P5026A-03B-S

Safety Service Note

P5026A Keysight Streamline USB Vector Network Analyzer

“POTENTIAL BURN INJURY (HIGH TEMPERATURE) HAZARD”

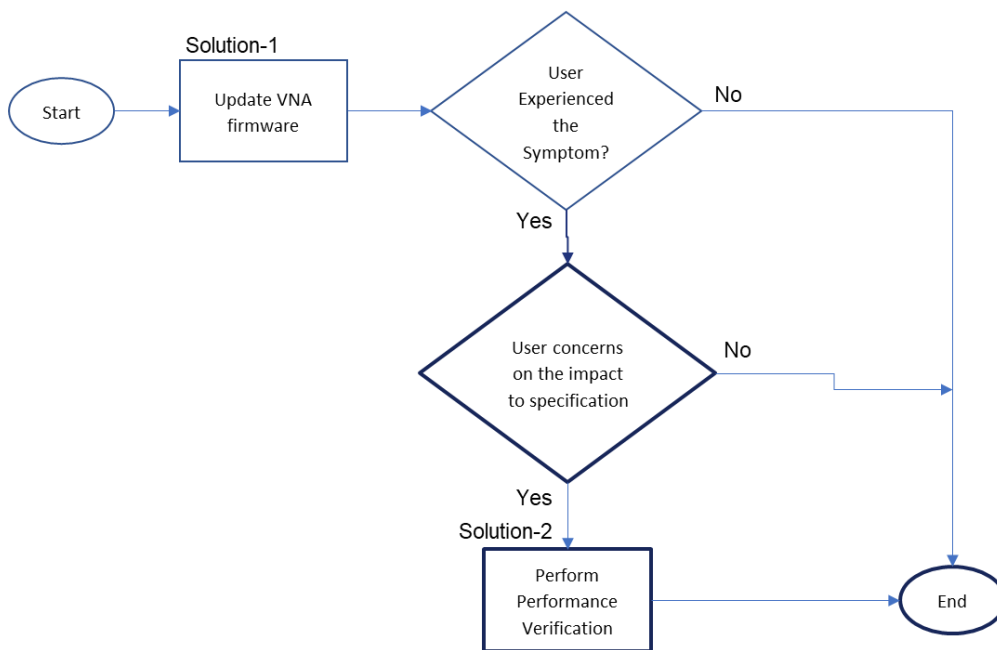
VNA fails to start with the following symptoms.

- 1. LED indicator (below circle) turns red.
- 2. cooling fan does not work
- 3. If user leaves the VNA with this LED indicator red without turning off power switch, it continues to overheat and becomes too hot.

Solution-1: Update VNA firmware by user

Solution-2: Perform Performance Verification by Keysight

1. **Install the latest VNA firmware Rev. A.15.40.13 or newer** on users' controller PC(s).
The latest firmware enhanced the thermal fan control mechanism.
2. Once the latest firmware is installed, proceed with the restart of both **controller PC** and **VNA**.
3. Launch the VNA firmware. Ensure VNA powers up and launches into firmware correctly after firmware update is done.
